DEPARTMENT OF COMMUNITY DEVELOPMENT SERVICES

m e m o r a n d u m

SUBJECT: **Plan Case No. 2148-CW-11:** 711 W. Western Ave., A request by the Central Illinois Mosque and Islamic Center for a Creekway Permit to construct a dormitory/gymnasium in the R-5, Medium High Density Multi-Family Residential Zoning District and the Boneyard Creek District.

SITE PLAN PLAN

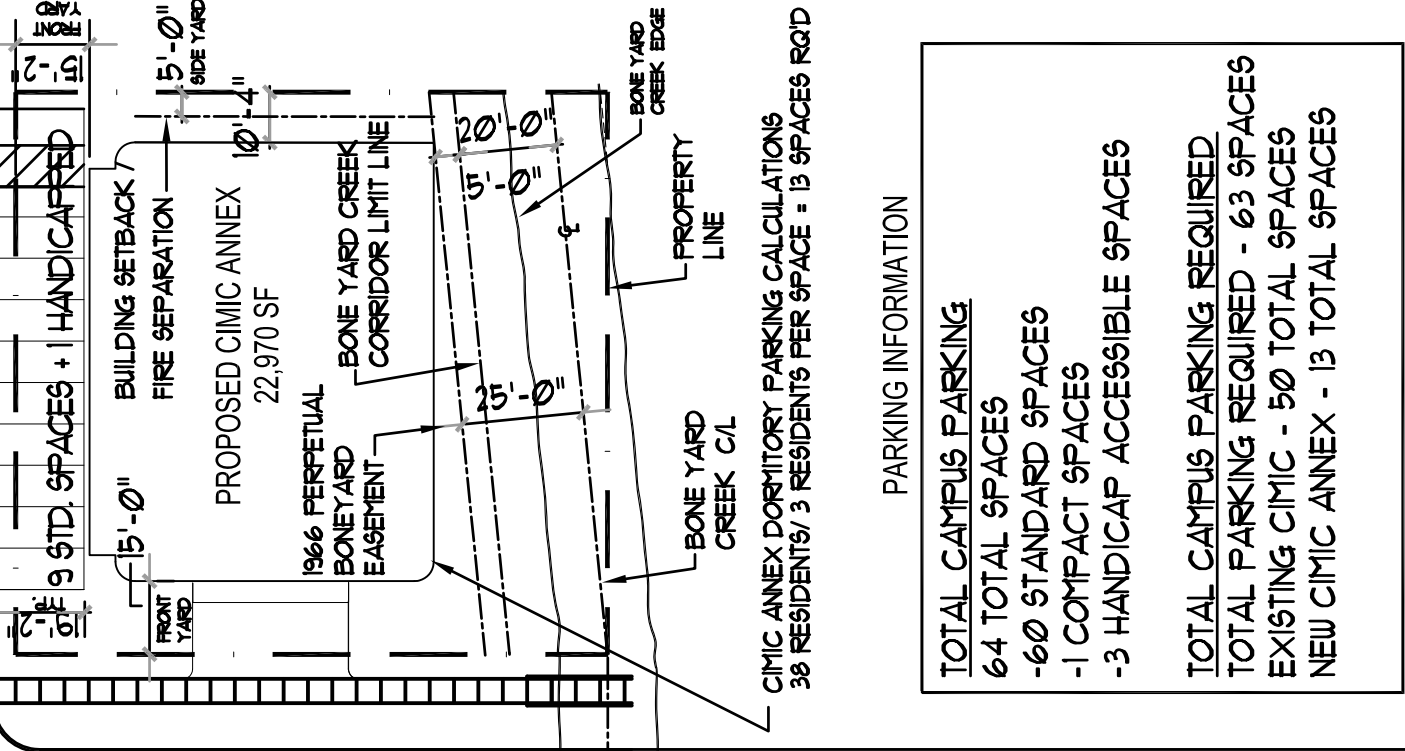
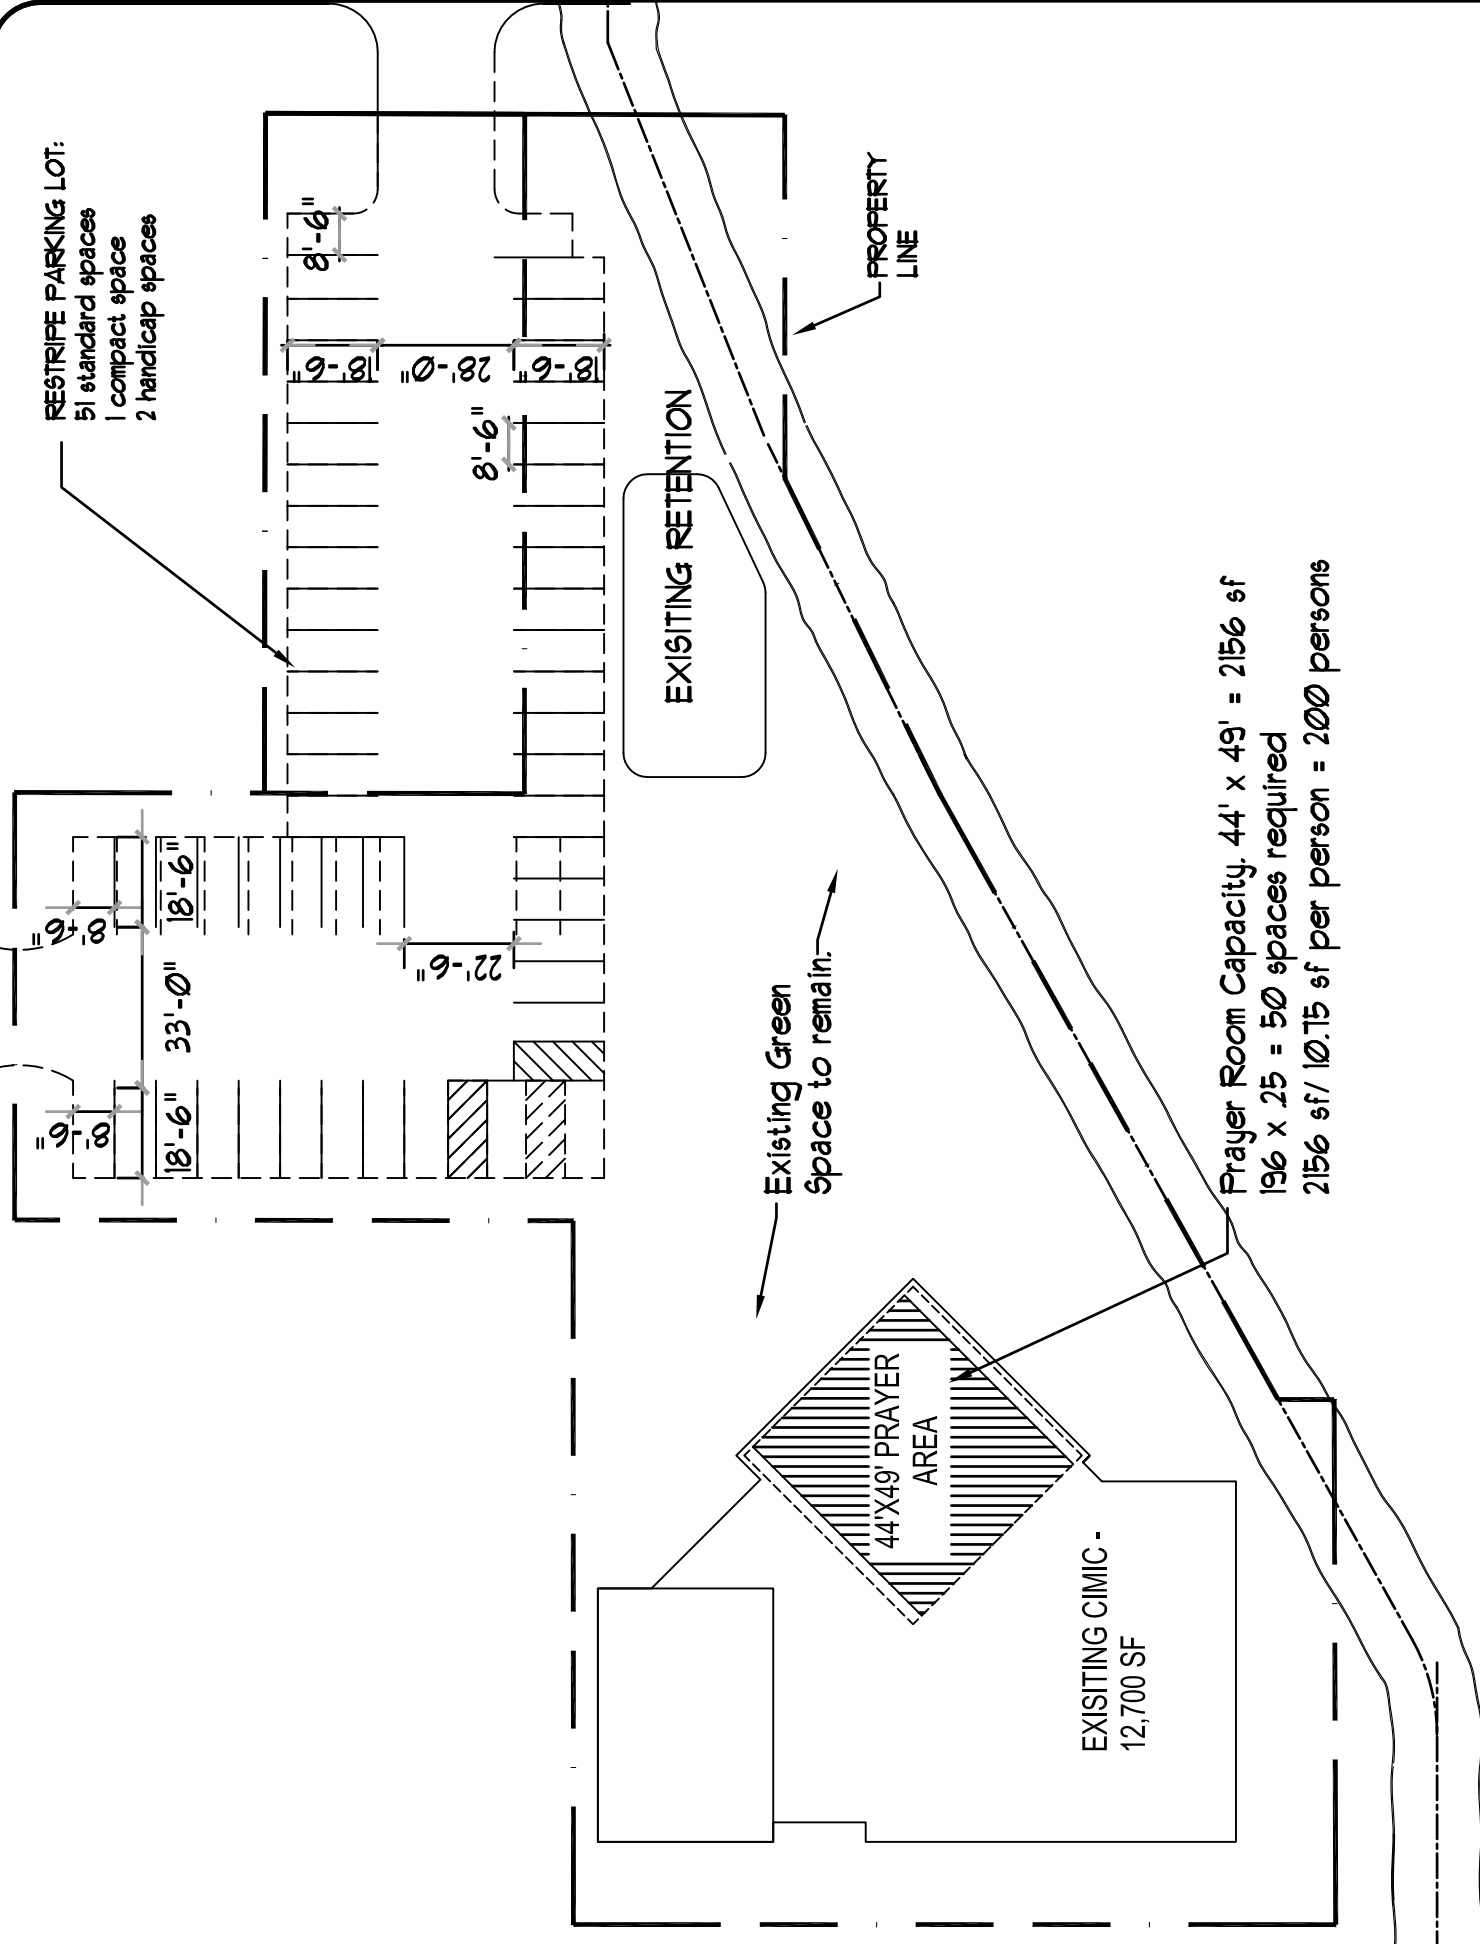
Parking. New parking for the proposed building would be located along Western Avenue and encroach entirely into the required yard. This 100% encroachment is made necessary to keep the building outside the Boneyard Creek floodway and 25 foot Creekway easement. The Zoning Ordinance (Section XIII-4.F.3) allows for site plan approval with a reduction of the required yard if approved by the Plan Commission.

If 90 degree parking is installed along Western Avenue, 10 parking spaces (nine standard and one handicapped) would be provided onsite. A drawback of providing parking in this configuration is that it would introduce cars backing out onto Western Avenue, and parking spaces would encroach into the street right-of-way approximately 3 feet 4 inches. Normally, private parking is not allowed to encroach in the right-of-way, but for this particular block parking encroachment in the right-of-way already exists. From the applicant's perspective this is necessary to allow the building to be constructed outside the floodway and still have the minimum amount of parking necessary. Parking below grade is not feasible in this instance due to periodic flooding. The City Engineer has indicated that parking encroachment could be acceptable if it will not encroach onto the pavement or create a conflict with service vehicles such as fire and trash trucks.

If parallel parking is installed along Western Avenue, five parking spaces (half as many) could be installed onsite, but the benefits would include elimination of backing onto the street, elimination of parking encroachment in the right-of-way, and provision of a sidewalk on the north side of the building.

In either scenario, parking space requirements for the entire campus (711 Western and 106 South Lincoln Ave.) will be met between the two properties. A total of 63 spaces would be required as a minimum, and 64 spaces are proposed to be provided with 90 degree parking along Western Avenue. Parallel parking on Western Avenue would place the campus four spaces short meaning the applicants would need to provide these additional spaces.

Ms. Tyler mentioned required setbacks and explained that parking in the setback along Western as proposed would require a variance. Mr. Cyrulik stated that they would be requesting a variance for the parking along Western. Ms. Tyler explained that a major variance may need to

be referred to the Zoning Board of Appeals or Plan Commission as the ordinance encourages moving away from the Boneyard. There was discussion about whether spaces on the north side of the building were needed and how a required handicap parking space would be provided.

1. Construction of parallel rather than 90 degree parking along Western Avenue. All other necessary parking is to be provided at the Mosque parking lot across Busey Avenue with a total of 63 spaces provided at a minimum for the campus.
2. Submittal of a landscape plan providing useable open area along the creek;
3. Dedicating a bikeway easement coincidental with the creek maintenance easement of 25 feet; and
4. Approval from the Illinois Department of Natural Resources.
